Planning Commission Minutes
April 27, 2023

21. (PUD-1943) Application by OKC L DEV., LLC ~~RSR240, LLC~~, to rezone 9900 Piedmont Road from R-1 Single-Family Residential District to PUD-1943 Planned Unit Development District. Ward 1.

STAFF REPORT
The City of Oklahoma City
Planning Commission
April 27, 2023

MASTER DEVELOPMENT PLAN

MASTER DEVELOPMENT PLAN OF
REDSTONE RANCH NORTH

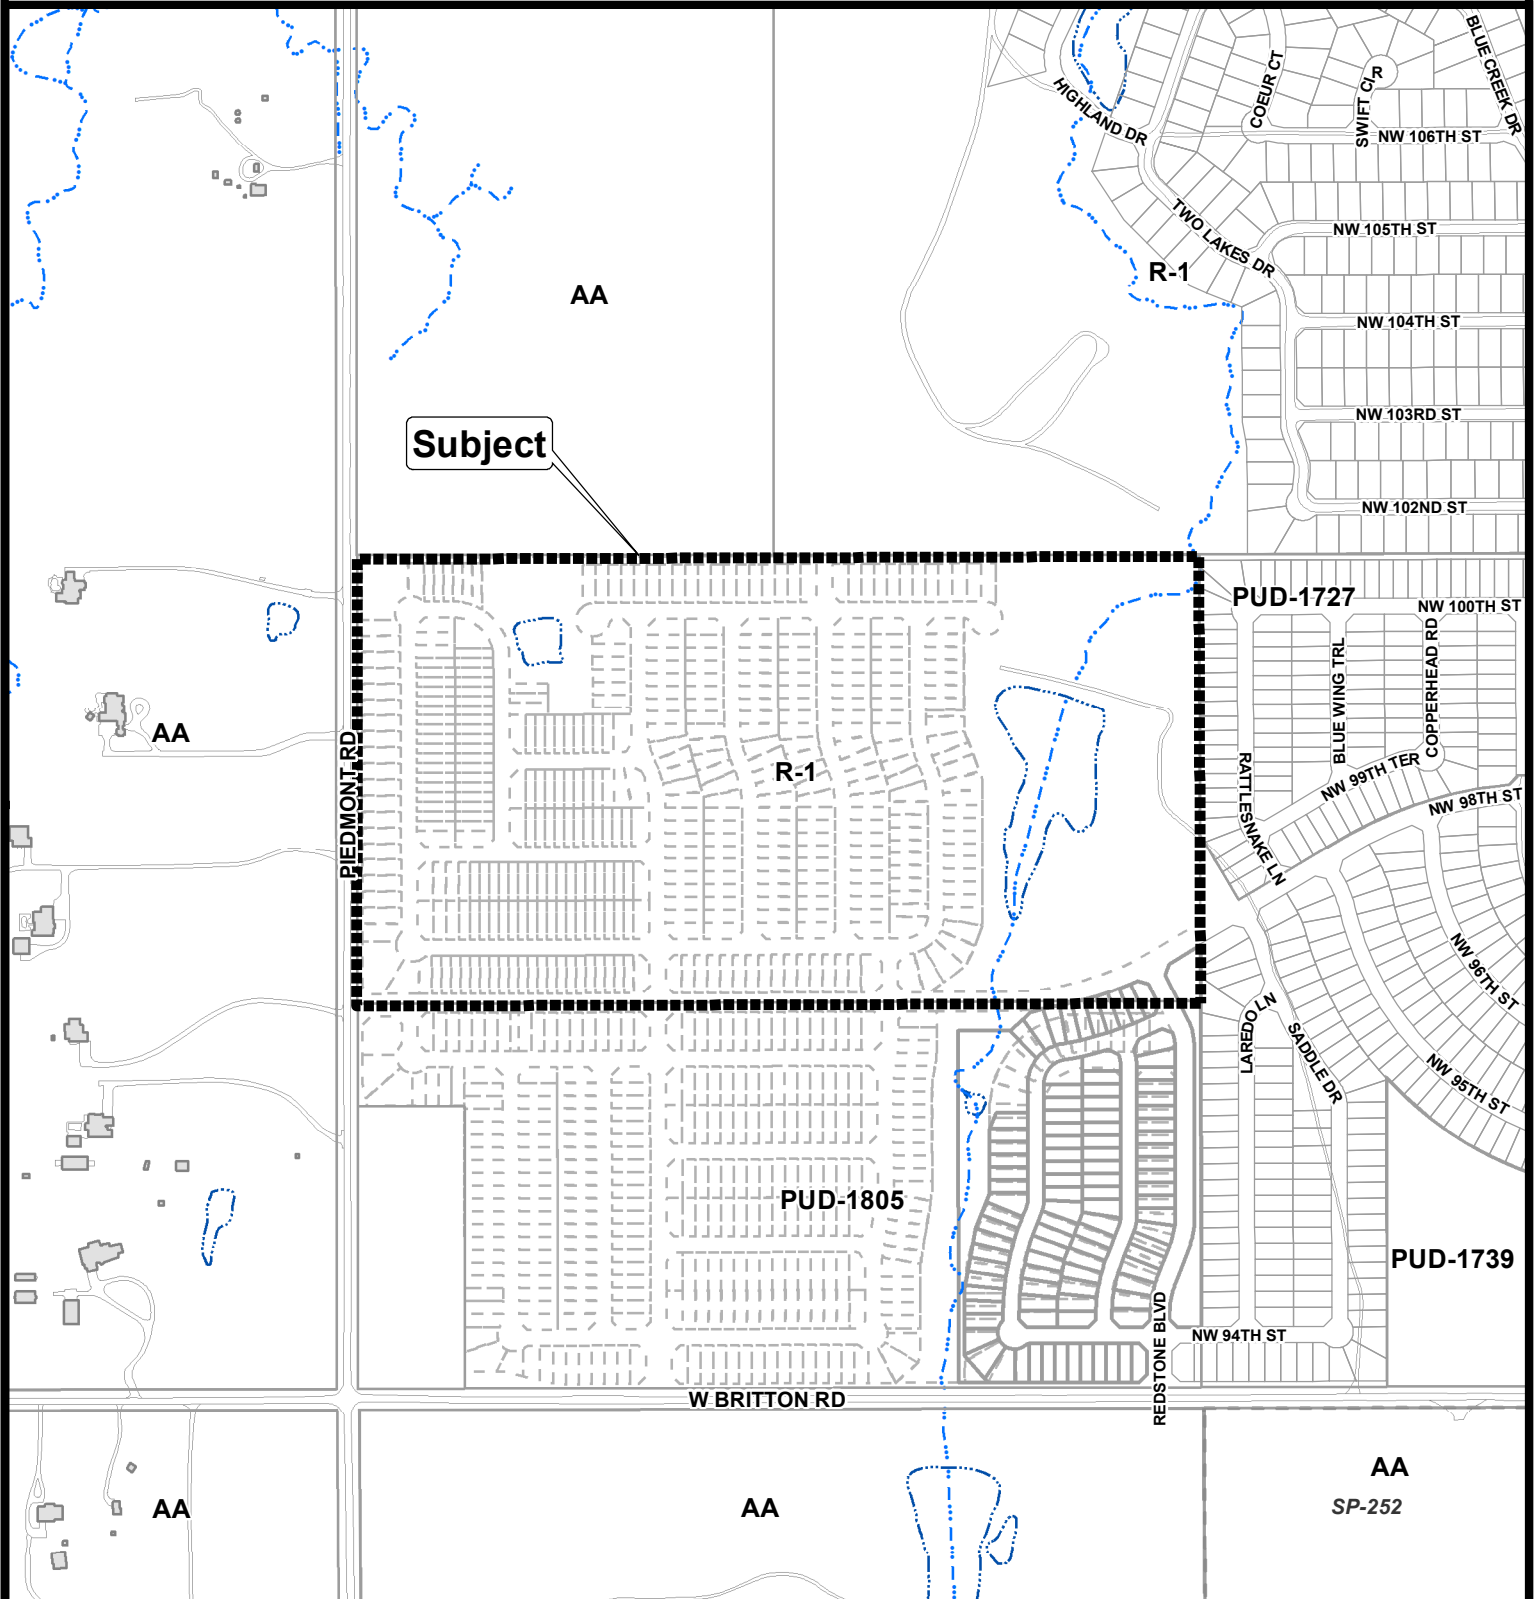
The subject site is located east of N Piedmont Road and north of W Britton Road. The site is zoned R-1 and was previously platted per the R-1 District regulations, which require minimum 6,000 square foot lots. The new PUD would rezone 85.44 acres into a new PUD to allow reduced residential lot sizes on two tracts. Tract 1, the 57 acres in the center of the site, proposes lot sizes of 4,800 square feet and 40-foot lot widths. Tract 2, the 27.85 acres on the west along Piedmont Road, proposes minimum lot sizes of 3,600 square feet and 30-foot widths, except along N Piedmont Road where lots would be required to meet the R-1 regulation of 6,000 square feet and 50-foot lot widths. The associated Preliminary Plat of Redstone Ranch North indicates the eastern third of the site (21 acres) will be common area/drainage.

The site is located in far west Oklahoma City, at the edge of the Urban Low Intensity LUTA. The proposed 400 lots over 85.44 acres would be a gross density of 4.68 dwelling units per acre, within the LUTA range. At least 25 acres of common area is proposed as indicated on the preliminary plat, but not specified in the PUD Master Design Statement. If the proposed lot sizes are allowed, the MDS should specify at least 20 percent of the PUD site will be open space/common area. Additionally, an internal trail/pedestrian network should be provided for residents in both tracts to connect to and through the common areas.

1. A minimum of 20 percent open space shall be provided within the PUD.
2. An internal pedestrian trail system shall be provided between tracts and to Common Areas A and B.
